Application of Pacific Gas and Electric Company (U39M) to Submit Its 2020 Risk Assessment and Mitigation Phase Report.	Application 20-06-012

ADMINISTRATIVE LAW JUDGE'S RULING INCLUDING SPD REPORT INTO RECORD OF PROCEEDING

Safety Policy Division Staff Evaluation Report on PG&E's 2020 Risk Assessment and Mitigation Phase (RAMP) Application (A.) 20-06-012

FIGURE 10-1. Risk Reduction with PSPS using PG&E's MAVF

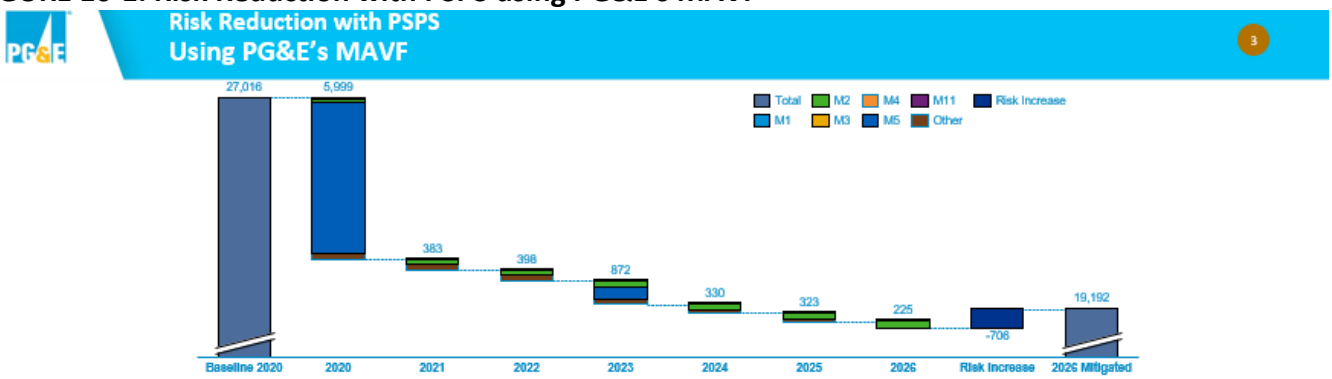
PG&E submitted both workpapers and a PowerPoint presentation dated October 2, 2020 entitled "WF Scenario Analysis Results – Without PSPS in the Portfolio" with associated new calculated RSEs and 'waterfall' graphs. Risk Reduction with PSPS using PG&E's MAVF is shown as a reference in slide three, copied into Table 10XA, including PG&E's associated waterfall graph with the July 17, 2020 errata reflected in the relevant program risk reductions. Then PG&E presents its Risk Reduction without PSPS using PG&E's MAVF in slide four, copied into FIGURE 10-1 on the following page.

FIGURE 10-2. Risk Reduction without PSPS using PG&E's MAVF

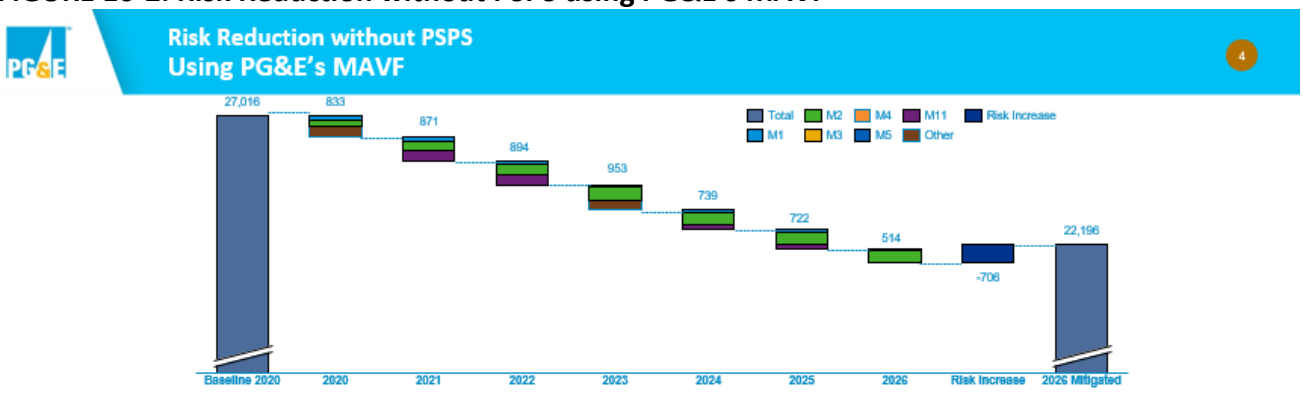
SPD also finds it is important to note that in TY2023, the Scenario Analysis WITHOUT PSPS includes 25 percent MA Risk Score increase due to Climate Change. SPD finds the Scenario Analysis WITHOUT PSPS allows for an important refinement to be able to begin to evaluate not only non-PSPS Mitigations risk reduction benefits but also impacts of PG&E's assumptions related to wildfire risk increases for the entire 2023-2026 GRC cycle. SPD finds that the impacts and relationships between Cross Cutting Mitigations, System Hardening, EVM, and Increased Climate Change Risk are more difficult to analyze when PSPS is included in the Wildfire Mitigation Portfolio as seen with the second half of Table 10-4.

SPD therefore recommends that PSPS be removed as a mitigation for the TY2023 GRC filing and that if desired, PG&E address PSPS impacts to wildfire MAVF risk analysis in other ways. SPD's recommendation to remove PSPS as a mitigation is in no way intended to discourage PG&E from utilizing PSPS to protect public safety as a measure of last resort and as allowed by the Commission in D.19-05-042. SPD's finding is both a result of WSD's identified deficiency that "RSE is not an appropriate tool for justifying the use of PSPS"[34] and SPD's observations stated above. Finally, SPD suggests PG&E consider alternative methodologies to analyze PSPS in its wildfire risk analysis for PG&E's TY2023 GRC filing.

FIGURE 10-2
RISK BOW TIE – HFTD ONLY

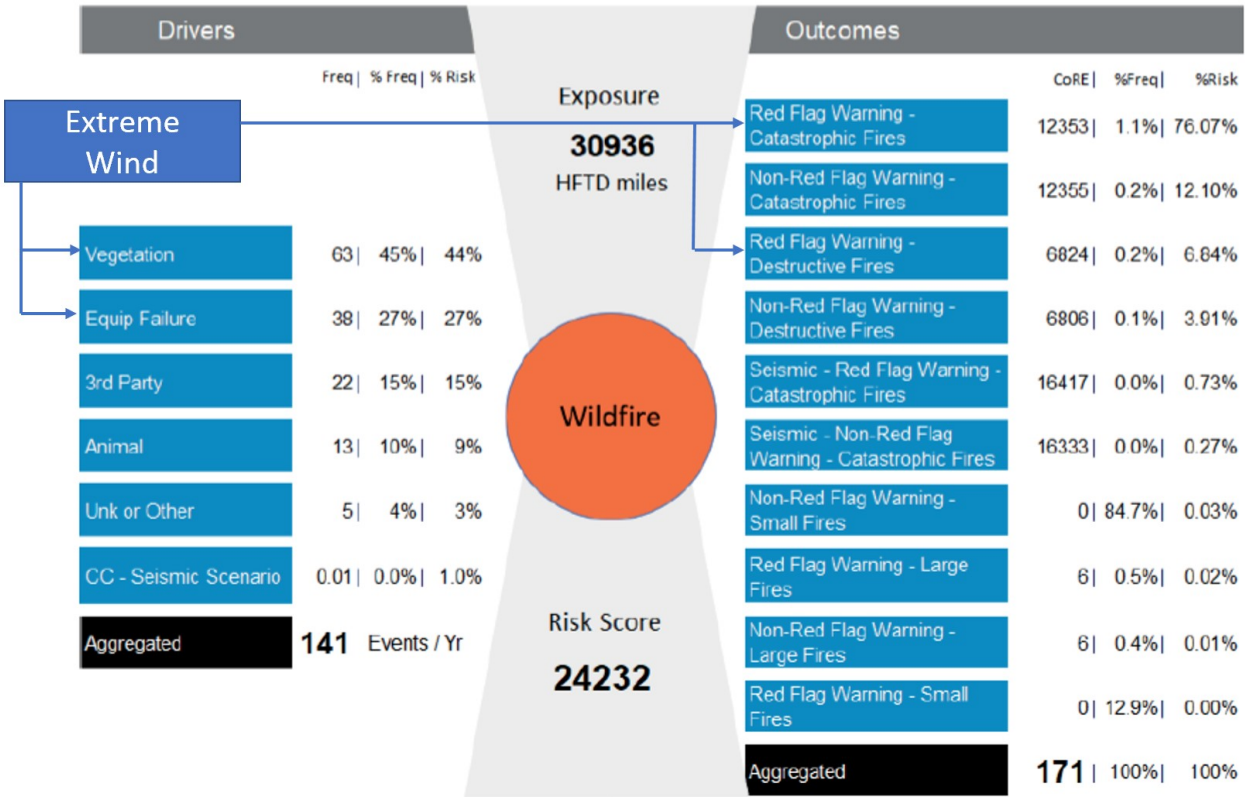
MGRA suggested an alternative version of PG&E's risk bow-tie, illustrated below:

In its response to TURN's suggestion from February of this year suggesting that wind is its own risk event, PG&E responded that using Red Flag Warning would provide a similar ability to track extreme fire risk. As noted in MGRA's protest, this is not adequate:
